# Technical Service Bulletin

## 40 Cracking noise from front end when changing direction

40 23 55 2061464/4 May 9, 2023. Supersedes Technical Service Bulletin Group 40 number 22-43 dated June 9, 2022, for reasons listed below.

**Figure 1.** Apply locking fluid around the threaded connection.

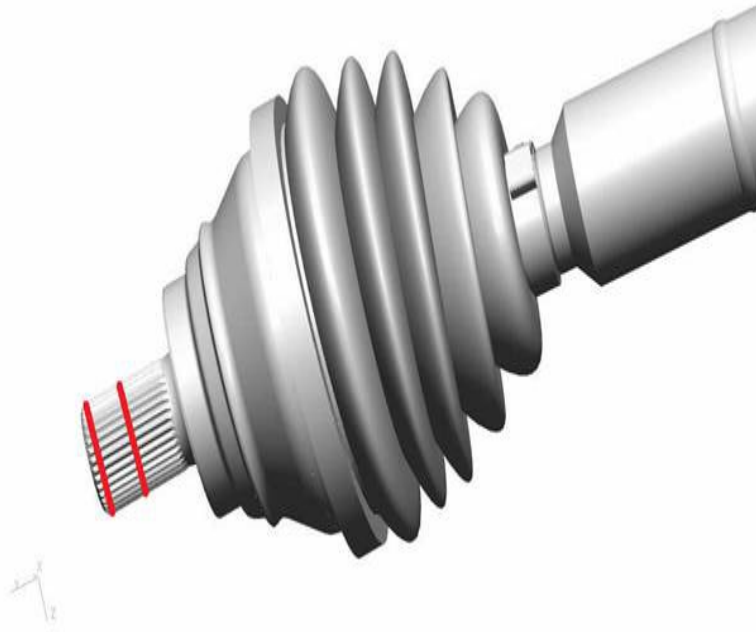
1. Follow instructions according to Elsa at Repair Manual, *Chassis >> Suspension, Wheels, Steering >> 40 Front Suspension >> Front Axle >> Drive Axle >> Drive Axle Disassembling, Assembling.*
2. Disassemble the affected drive axle.
3. Apply liquid locking fluid as shown in Figure 1 (red lines around the threaded connection).

4. Reinstall the drive axle according to ELSA instructions.

**After assembling the drive axle(s), the vehicle must not be operated for 8 hours.**
